ECE/TRANS/WP.29/2009/15  
17 December 2008

Proposal for Supplement 15 to the 02 series of amendments to Regulation No. 7  
(Front and rear position (side) lamps, stop lamps and end-outline marker lamps)

Submitted by the Working Party on Lighting and Light-Signalling (GRE) \*/

"Annex 1

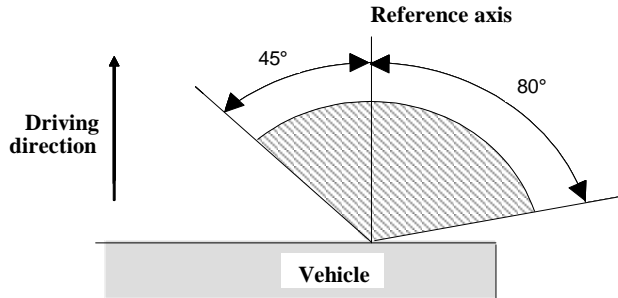
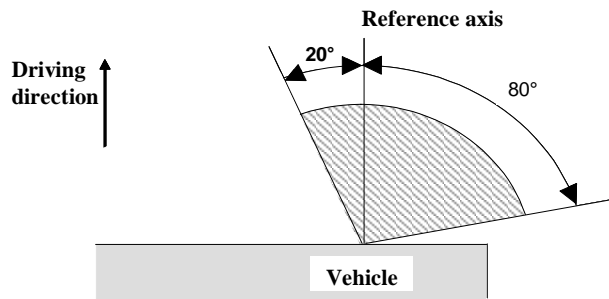
Annex 1, amend to read:

On and above the H  
plane for all lamps.  
Under the H plane for  
lamps intended for  
M2, M3, N2 or N3  
category vehicles.

Front position lamps,  
Under the H plane for  
M1 or N1 category  
vehicles.
